PCI-SIG ENGINEERING CHANGE NOTICE

TITLE:	Internal Error Reporting
DATE:	April 24, 2008
AFFECTED DOCUMENT:	PCI Express Base Specification, version 2.0
SPONSOR:	Integrated Device Technology, Hewlett-Packard, Sun, Intel, PLX Technology, NextIO

Figure 6-1: Error Classification

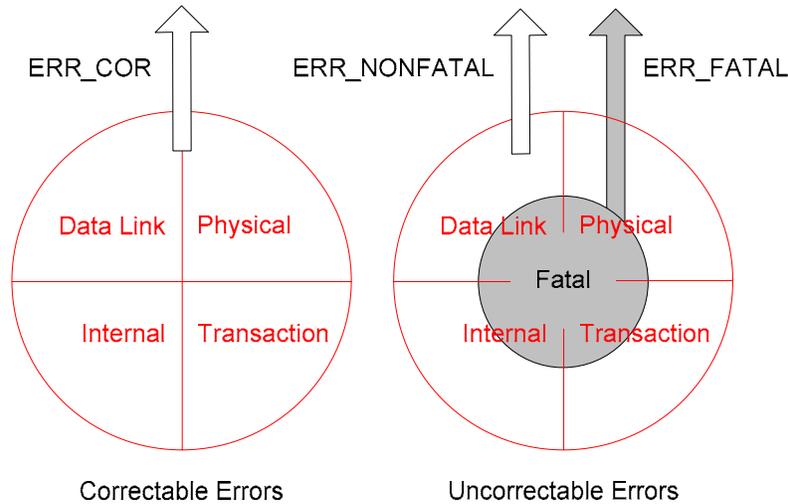
Update Section 6.2.2 as follows:

Figure 6-1: Flowchart Showing Sequence of Device Error Signaling and Logging Operations

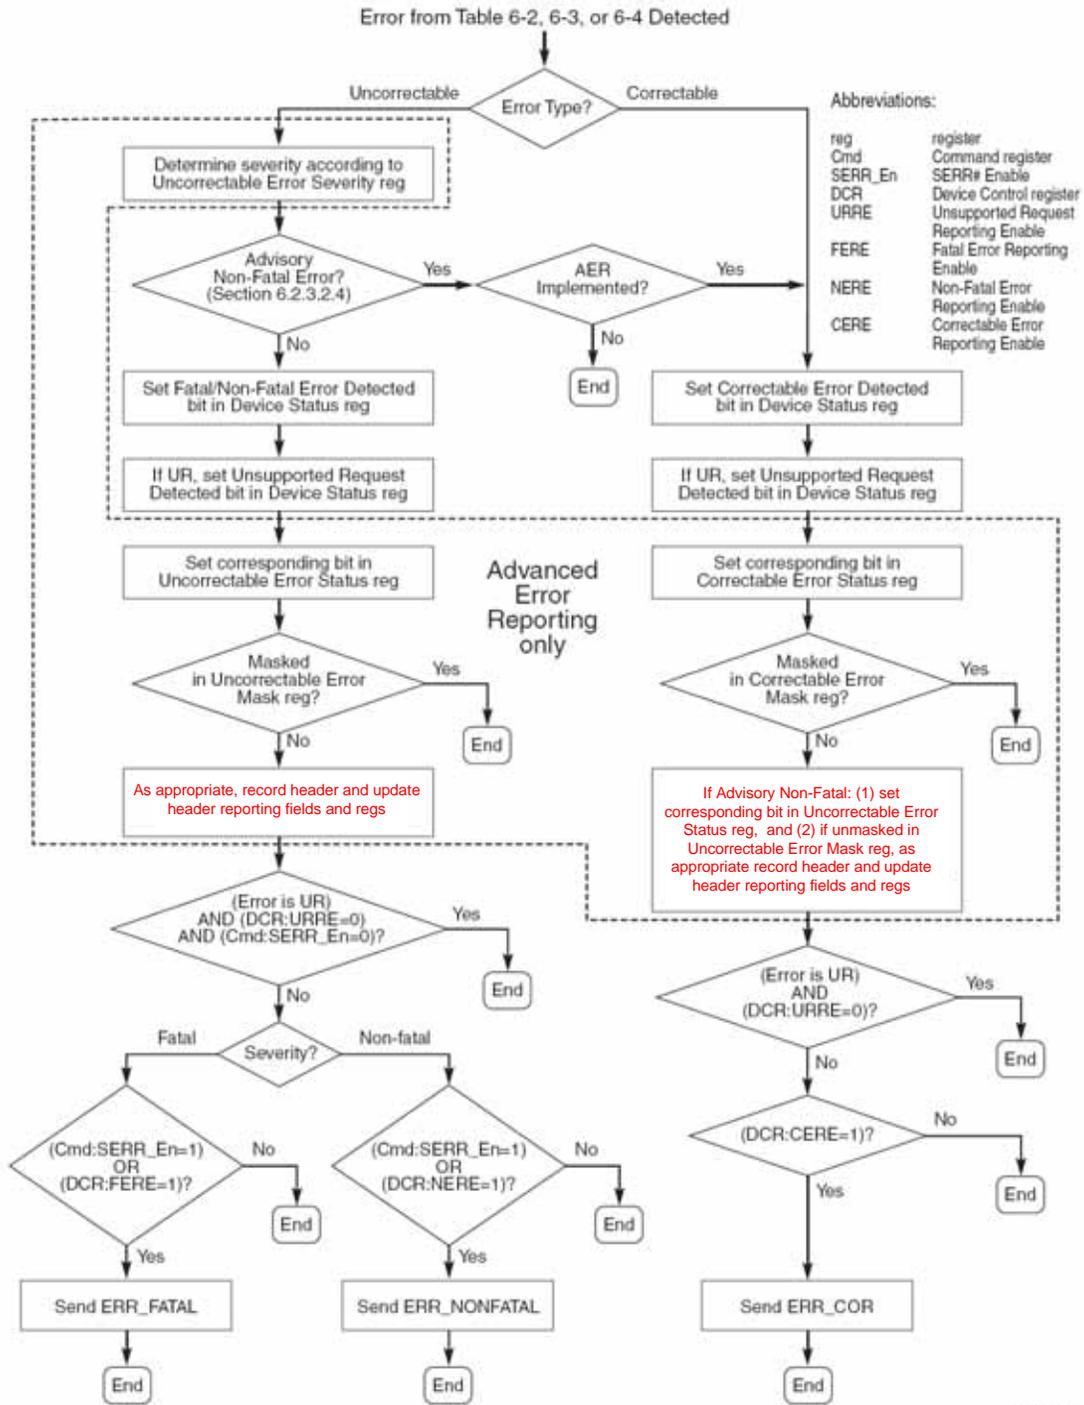
Update Section 6.2.5 as follows:

Figure 6-2 shows the sequence of operations related to signaling and logging of errors detected by a device.

Figure 7-32: Uncorrectable Error Status Register

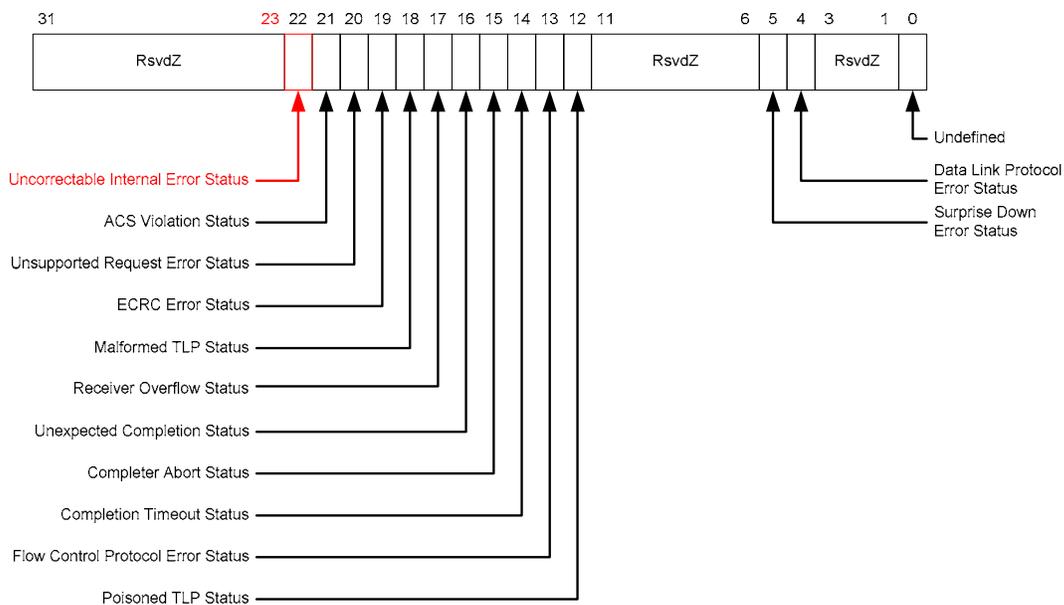
Update Section 7.10.2 as follows:

Bit Location	Register Description	Attributes	Default
4	Data Link Protocol Error Status	RW1CS	0b
5	Surprise Down Error Status (Optional)	RW1CS	0b
12	Poisoned TLP Status	RW1CS	0b
13	Flow Control Protocol Error Status (Optional)	RW1CS	0b
14	Completion Timeout Status ¹⁶	RW1CS	0b
15	Completer Abort Status (Optional)	RW1CS	0b
16	Unexpected Completion Status	RW1CS	0b
17	Receiver Overflow Status (Optional)	RW1CS	0b
18	Malformed TLP Status	RW1CS	0b
19	ECRC Error Status (Optional)	RW1CS	0b
20	Unsupported Request Error Status	RW1CS	0b
21	ACS Violation Status	RW1CS	0b
<u>22</u>	<u>Uncorrectable Internal Error Status (Optional)</u>	<u>RW1CS</u>	<u>0b</u>

Figure 7-33: Uncorrectable Error Mask Register

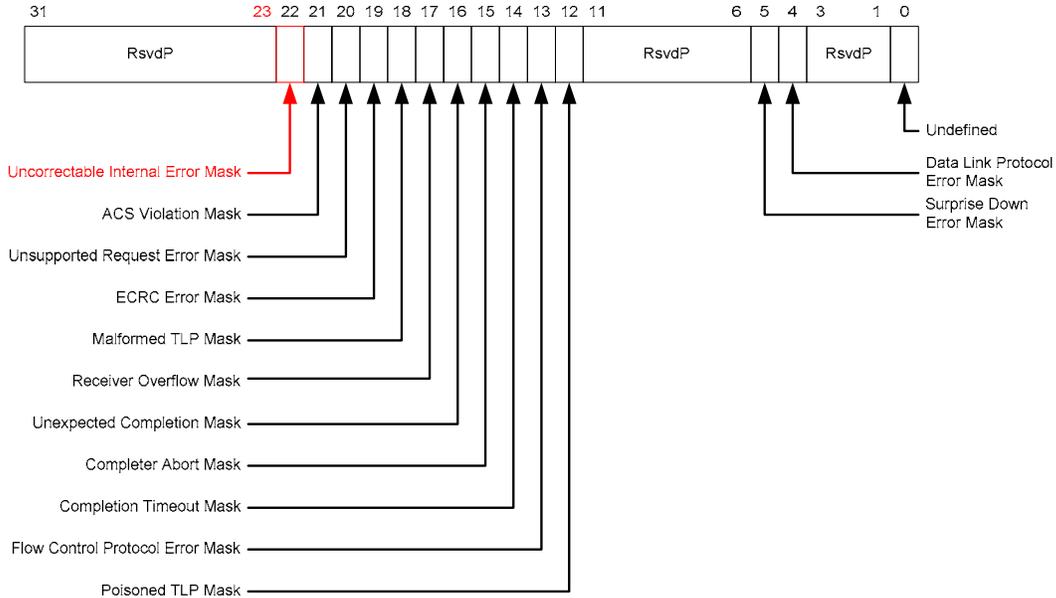
Update Section 7.10.3 as follows:

Bit Location	Register Description	Attributes	Default
21	ACS Violation Mask	RWS	0b
<u>22</u>	<u>Uncorrectable Internal Error Mask (Optional)</u>	<u>RWS</u>	<u>1b</u>

Figure 7-34: Uncorrectable Error Severity Register

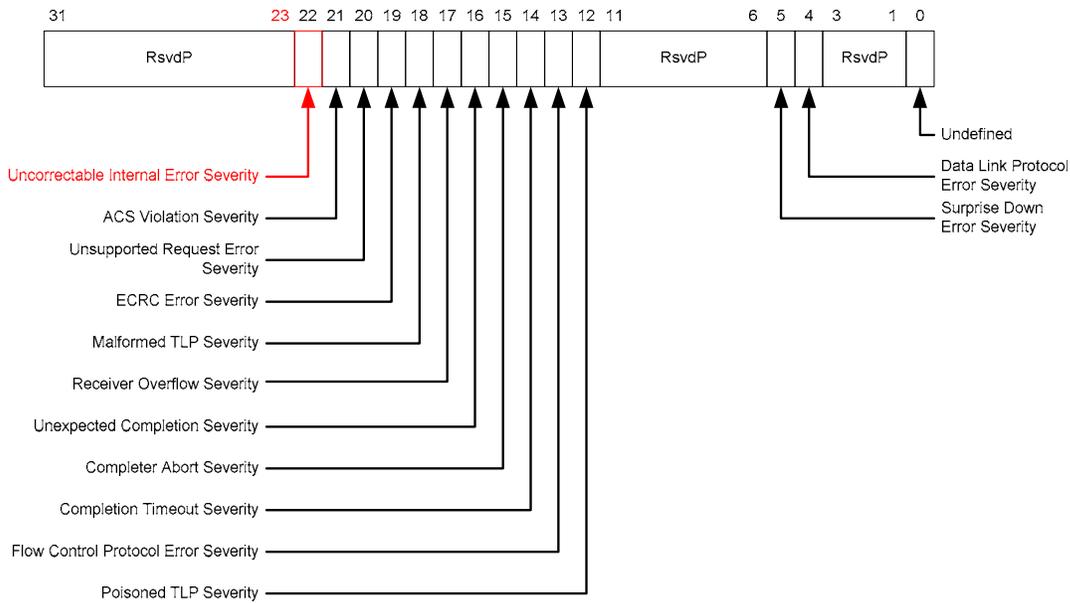
Update Section 7.10.4 as follows:

permitted to write any value to this bit.		
4	Data Link Protocol Error Severity	RWS	1b
5	Surprise Down Error Severity (Optional)	RWS	1b
12	Poisoned TLP Severity	RWS	0b
13	Flow Control Protocol Error Severity (Optional)	RWS	1b
14	Completion Timeout Error Severity ¹⁸	RWS	0b
15	Completer Abort Error Severity (Optional)	RWS	0b
16	Unexpected Completion Error Severity	RWS	0b
17	Receiver Overflow Error Severity (Optional)	RWS	1b
18	Malformed TLP Severity	RWS	1b
19	ECRC Error Severity (Optional)	RWS	0b
20	Unsupported Request Error Severity	RWS	0b
21	ACS Violation Severity	RWS	0b
<u>22</u>	<u>Uncorrectable Internal Error Severity (Optional)</u>	<u>RWS</u>	<u>1b</u>

Figure 7-35: Correctable Error Status Register

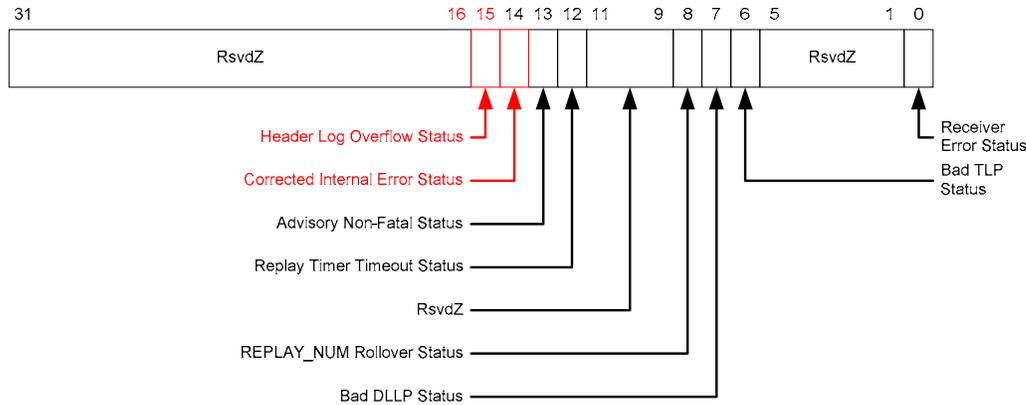
Update Section 7.10.5 as follows:

Bit Location	Register Description	Attributes	Default
0	Receiver Error Status ¹⁹	RW1CS	0b
6	Bad TLP Status	RW1CS	0b
7	Bad DLLP Status	RW1CS	0b
8	REPLAY_NUM Rollover Status	RW1CS	0b
12	Replay Timer Timeout Status	RW1CS	0b
13	Advisory Non-Fatal Error Status	RW1CS	0b
14	<u>Corrected Internal Error Status (Optional)</u>	<u>RW1CS</u>	<u>0b</u>
15	<u>Header Log Overflow Status (Optional)</u>	<u>RW1CS</u>	<u>0b</u>

Figure 7-36: Correctable Error Mask Register

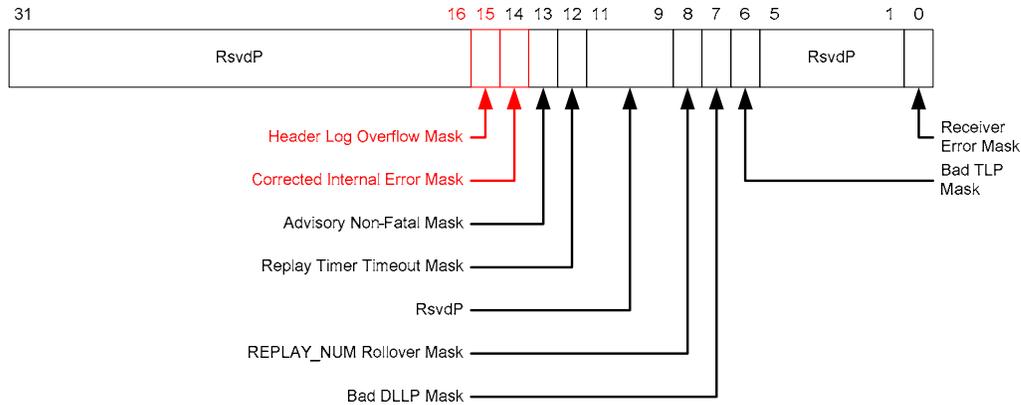
Update Section 7.10.6 as follows:

Bit Location	Register Description	Attributes	Default
0	Receiver Error Mask ²⁰	RWS	0b
6	Bad TLP Mask	RWS	0b
7	Bad DLLP Mask	RWS	0b
8	REPLAY_NUM Rollover Mask	RWS	0b
12	Replay Timer Timeout Mask	RWS	0b
13	Advisory Non-Fatal Error Mask – This bit is Set by default to enable compatibility with software that does not comprehend Role-Based Error Reporting.	RWS	1b
<u>14</u>	<u>Corrected Internal Error Mask (Optional)</u>	<u>RWS</u>	<u>1b</u>
<u>15</u>	<u>Header Log Overflow Mask (Optional)</u>	<u>RWS</u>	<u>1b</u>

Figure 7-37: Advanced Error Capabilities and Control Register

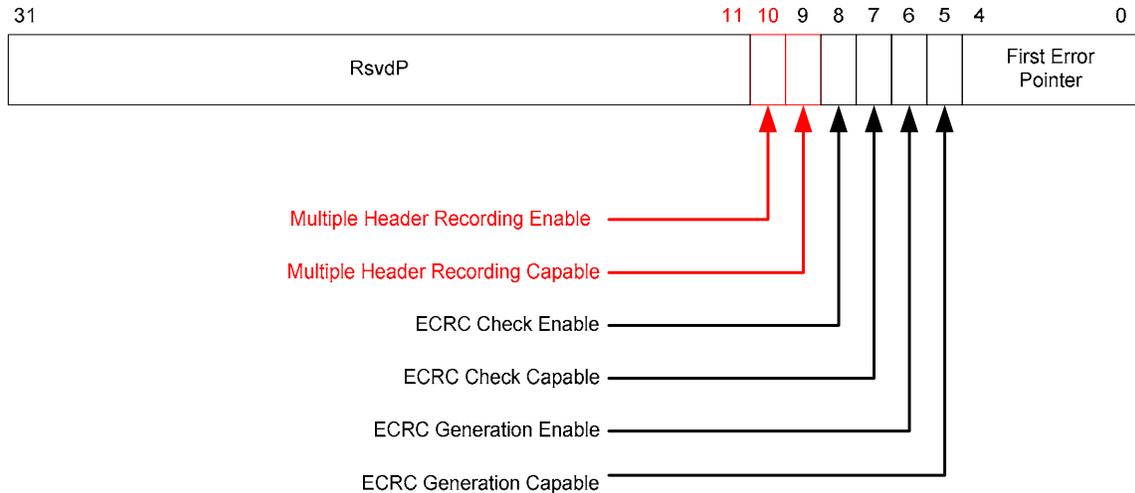
Update Section 7.10.7 as follows:

9	Multiple Header Recording Capable – If Set, this bit indicates that the Function is capable of recording more than one error header. Refer to Section 6.2 for further details.	RO

Bit Location	Register Description	Attributes
<u>10</u>	<p><u>Multiple Header Recording Enable – When Set, this bit enables the function to record more than one error header.</u></p> <p><u>Functions that do not implement the associated mechanism are permitted to hardwire this bit to 0b.</u></p> <p><u>Default value of this bit is 0b.</u></p>	<u>RWS</u>

Figure 7-38: Header Log Register

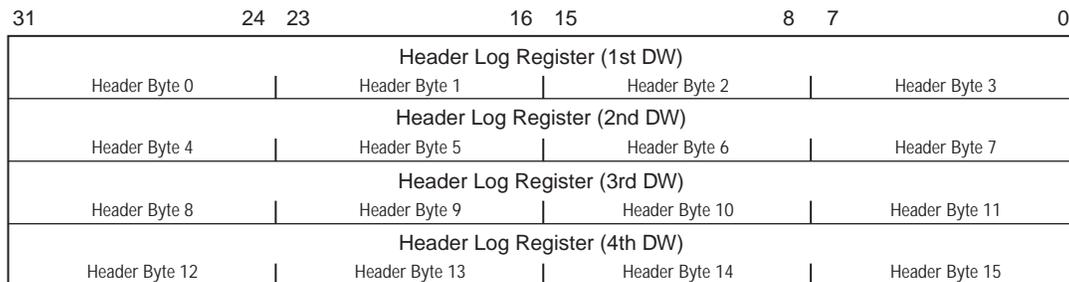
Update Section 7.10.8 as follows:

The Header Log register ~~captures~~ contains the header for the TLP corresponding to a detected error; refer to Section 6.2 for further details. Section 6.2 also describes the conditions where the packet header is ~~logged~~ recorded. This register is 16 bytes and adheres to the format of the headers defined throughout this specification.
